ADDENDUM #1

TO: ALL PLAN HOLDERS AND POTENTIAL BIDDERS
FROM: RON VENTURELLA, PURCHASING OFFICER *RV*
SUBJECT: ADMINISTRATIVE SERVICES FREEZER/COOLER DOOR (RFP 43-12)

FREEZER DOOR RENOVATIONS FOR:
BUNCOMBE COUNTY SCHOOLS
 175 BINGHAM ROAD
 ASHEVILLE, NORTH CAROLINA

Issued for: PERMIT
 Date: 19 OCT 2012
 Add. #1: 31 OCT 2012
 Job #: 12280
 PLANS & DETAILS

A102

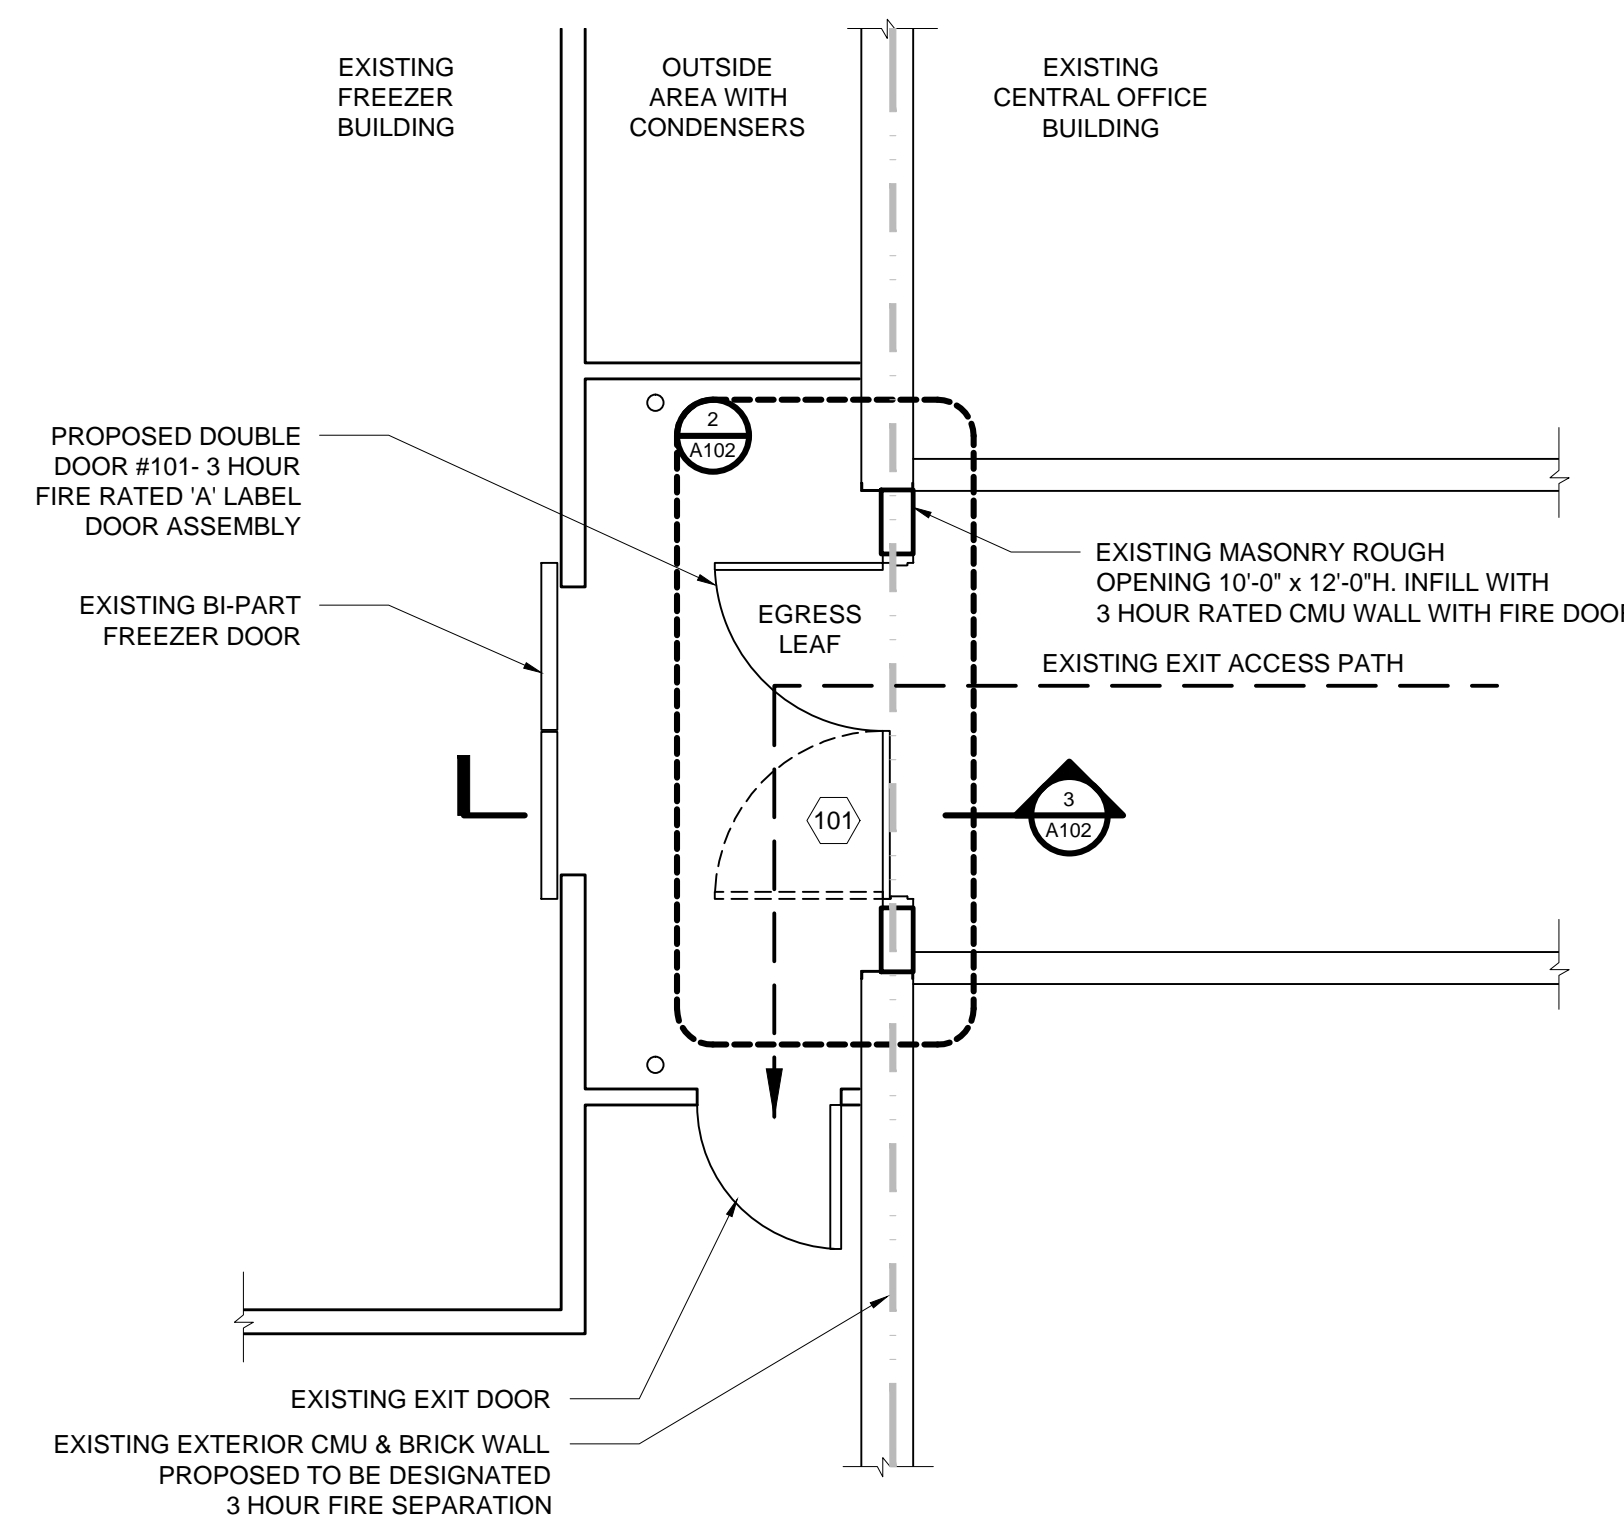
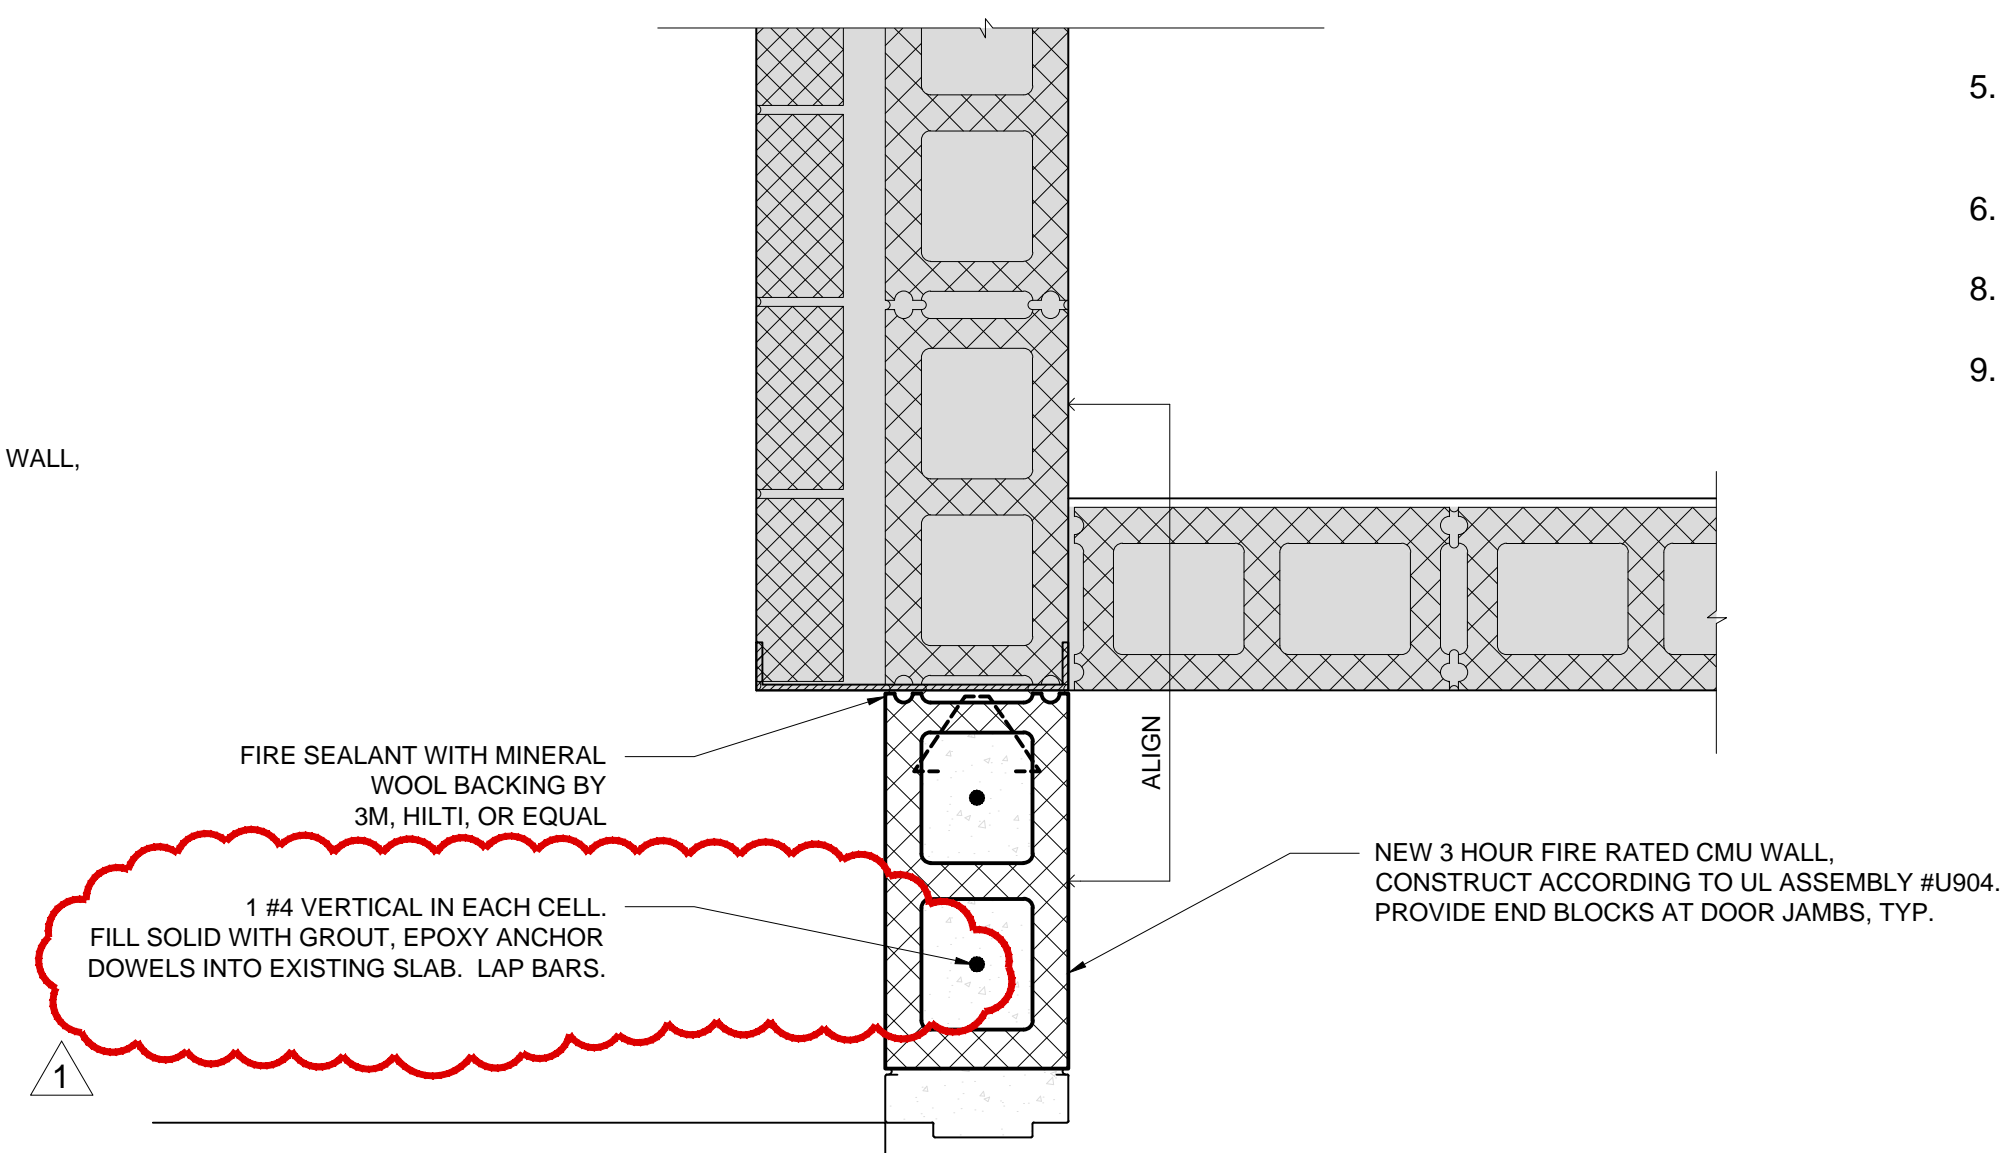
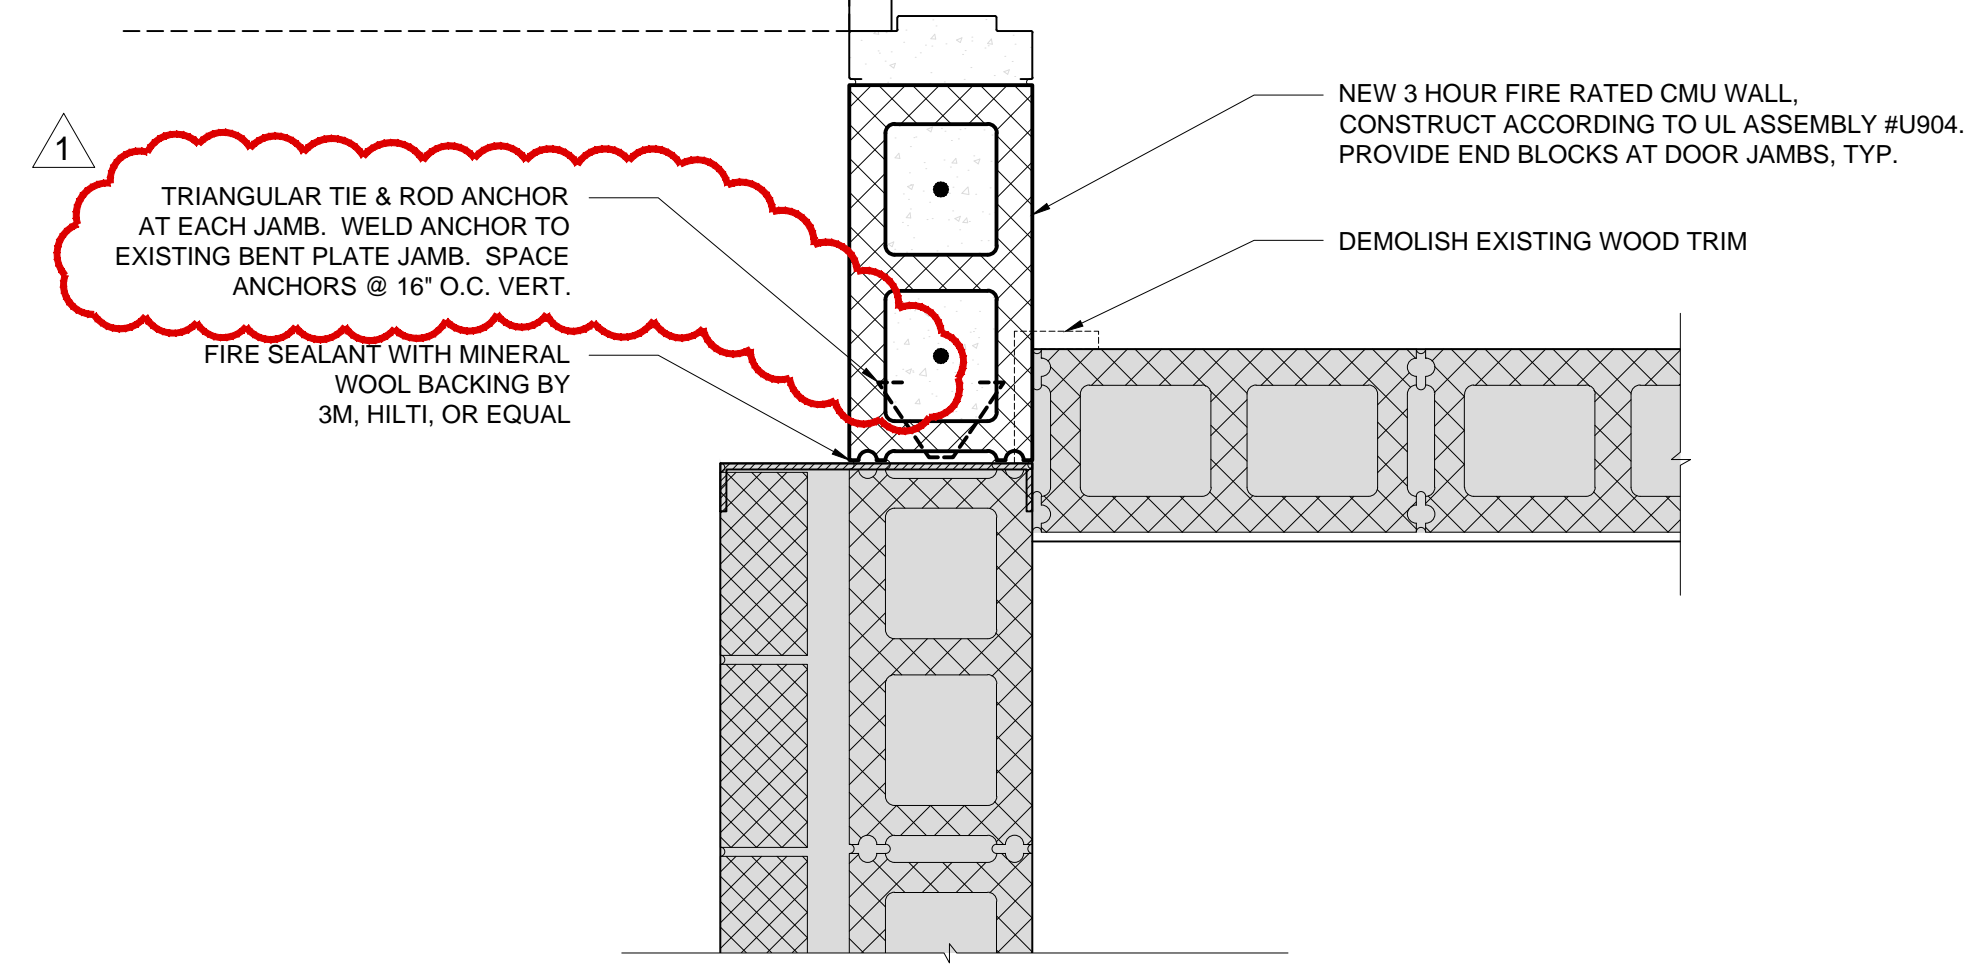
5. Reference drawing A 102: CMU reinforcing clarifications have been added to the drawing. See attached revised drawing dated October 31, 2012.
6. Revised proposal form attached.
